## Technical Note: Spindlewood Drive, Bexhill-on-Sea

**Project:** 1764 – Spindlewood Drive

Date: 16 April 2019

Revision: 2\_Final

Figure 1 – Indicative drainage layout plan showing the proposed SuDS and revised wetland extent, following natural the natural topography.

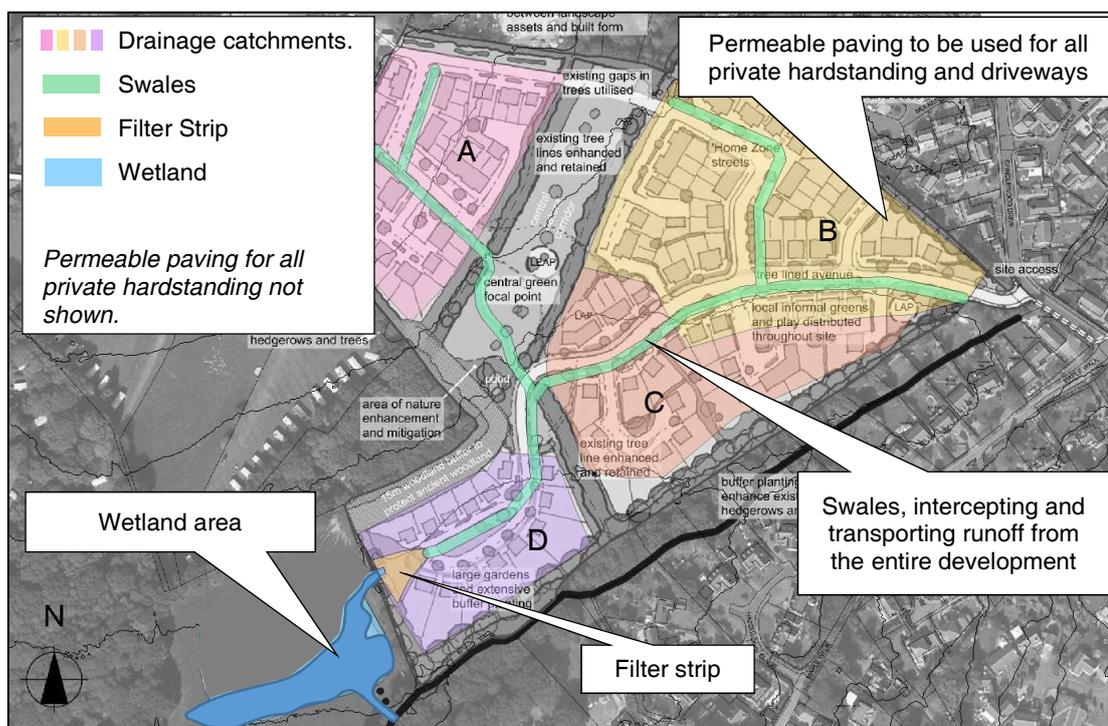
- 2.8. In response to the comments raised by SPINDAG, and in particular the comments from Geoffrey Lawson relating to the higher than anticipated groundwater level and potential need for ballasting, the wetland system was redesigned. The redesign was based on the assumption that the groundwater level was significantly higher than was first assumed in the original FRA and technical addendum, and presented two possible cases;

- 2.2. The proposed drainage strategy uses a combination of Sustainable Drainage Systems (SuDS) to provide stormwater storage, habitat space, and benefits to water quality. The details can be found in the technical addendum appended, however, in summary water from the proposed development is discharged into a series of swales passing through the development, which flow into a filter strip (shown in Figure 1). This system provides a mechanism for transporting surface water runoff across the site and trapping any contaminants *before* they are discharged into the adjacent proposed wetland.

- 2.3. The proposed wetland area has been designed to provide habitat space, water quality improvements and to store water in a controlled way, before allowing clean water to be discharged to the adjacent Cole Stream at an attenuated rate (replicating the undeveloped conditions).

Figure 1 – Indicative drainage layout plan showing the proposed SuDS and revised wetland extent, following natural the natural topography.

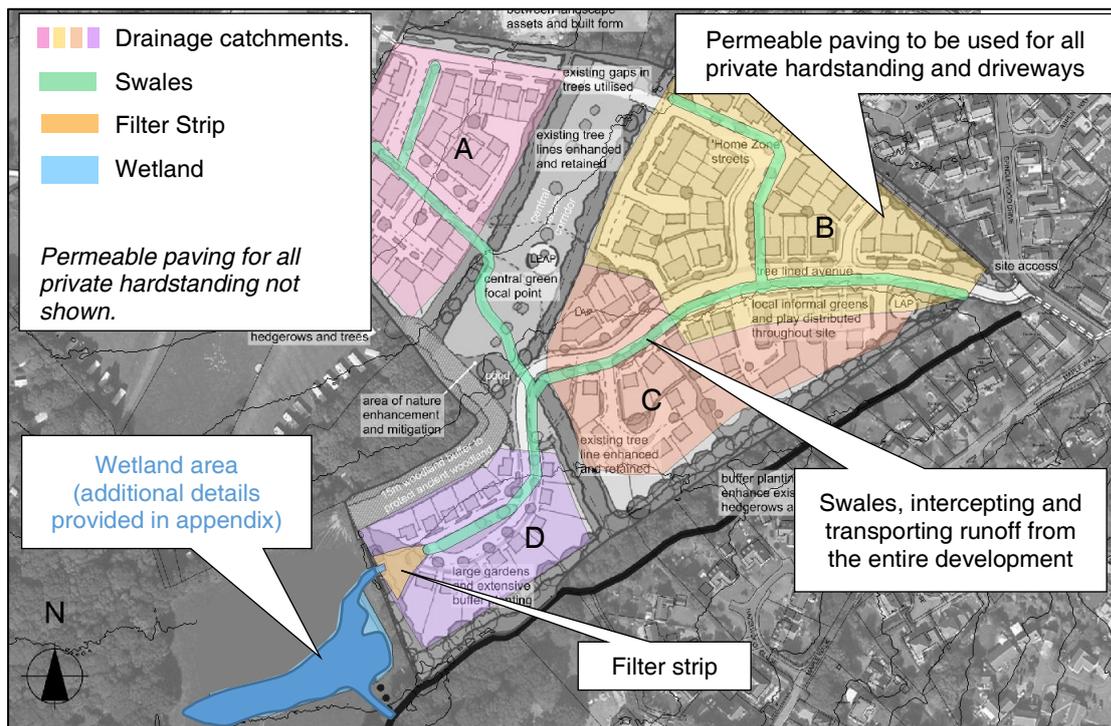
2. An assessment of the land levels across the site to ensure that, based on a block masterplan layout, the entire site can be drained to the wetland area (e.g. via swales), even in the event that the wetland area has to be raised. It was agreed that this can be demonstrated by undertaking a site specific topographic survey and the singular cross section and singular longitudinal sections discussed during the meeting were considered appropriate. The site specific topographic survey will be used to verify the aerial height (LiDAR) data for the wider site and the topographic survey should include the bank of the river and the water level. This will enable an outline drainage design to be tested.

3.1 The development site has been split into four separate drainage catchments which are labelled A-D on Figure 1 Below. Figure 1 also indicates where the proposed SuDS could be located across the site.

Figure 2 – Extract from section drawing through the proposed wetland.

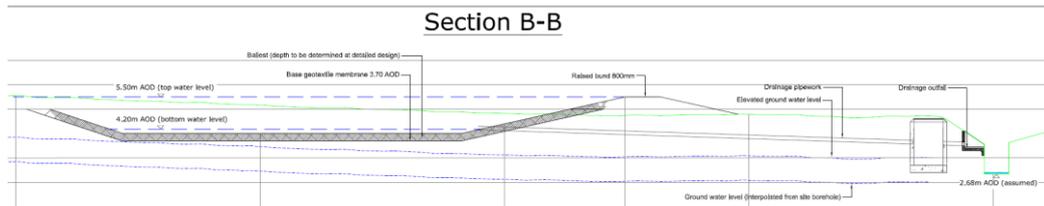
3. Details of suitable methods for tanking the wetland area in the event groundwater levels are elevated, that do not include using a concrete lining. It is proposed to submit the worst case scenario in all instances to provide a conservative approach when designing the wetland (as requested by NE). Details of the proposed size of the bund are also to be provided (as requested by NE).

5.8 The wetland has been redesigned to follow the natural contours of the site, reducing the overall footprint. The volume of storage required to attenuate the surface water runoff discharged from the proposed development remains unchanged (3,230m<sup>3</sup>), however, the base of the wetland will be excavated to a level no lower than 4m AODN. 1m of soil will therefore remain between the base of the wetland (adjacent to the watercourse) and the current (assumed) groundwater level, based on the borehole information. At the northern edge of the wetland the liner would be located 0.5m above the groundwater level.

5.10 The active water depth within the wetland is shown to be 1.3m deep, with a permanent wet area (assumed to be 200mm in depth) included on the section detail. With the base of the wetland located at 4m AODN this provides ~ 700mm below the invert of the filter strip. This provides the opportunity to provide a series of staged shallow entry pools, offering further opportunities for pollution control and silt entrapment. It is envisaged that the flow control device and outfall will be located no lower than 4.2m AODN. Alternatively, if seasonal groundwater monitoring indicates that the groundwater level is higher than estimated, it is evident that the wetland can be raised above the ground and still be located 200mm below the invert level of the filter strip.

Figure 3 – Indicative foul drainage strategy.

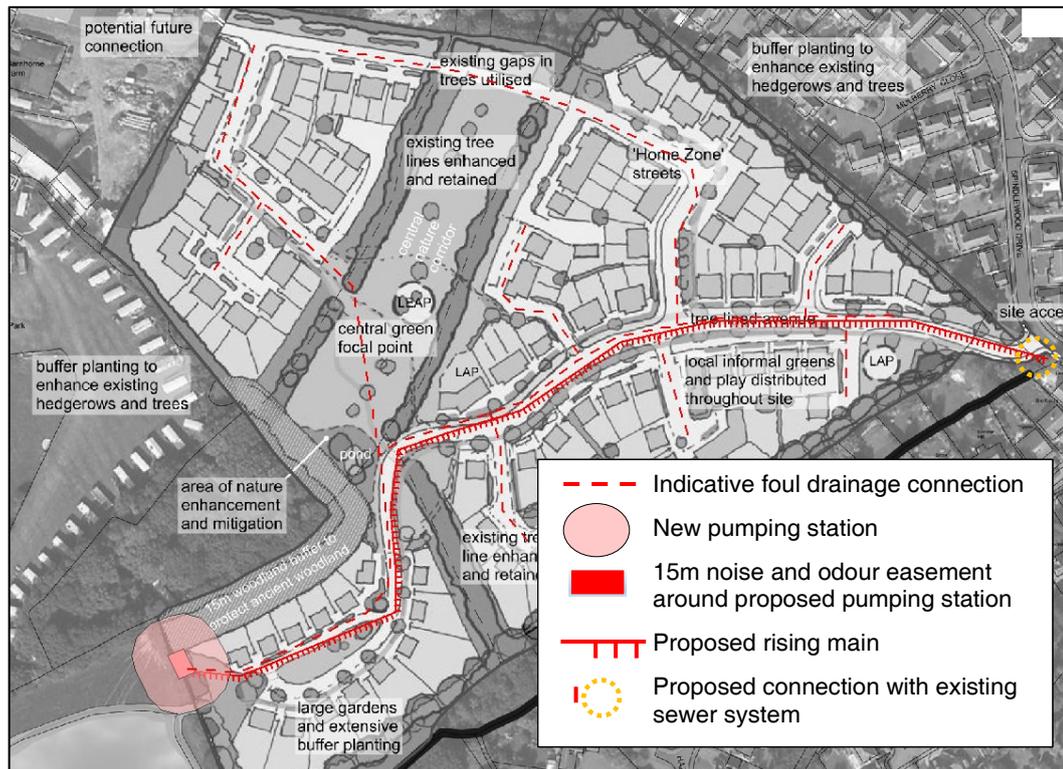
5. Indicative foul water connections to be shown on the layout plan to indicate the possible connection points to the public foul sewer. It was agreed by the group that the development will not discharge foul effluent to a package treat plant and instead will be directed to the public sewer. If pumped, a back-up pump will be specified to ensure that the risk of pollution to the SSSI/RAMSAR/SAA is mitigated should the primary pump fail. This detail will be included within the addendum report, however, the group agreed that it was sufficient at this time to agree a suitably worded condition in respect of future detailed design.

9.6 From Figure 3 (above) it is evident that a solution for draining foul effluent into the existing public sewer system is available.
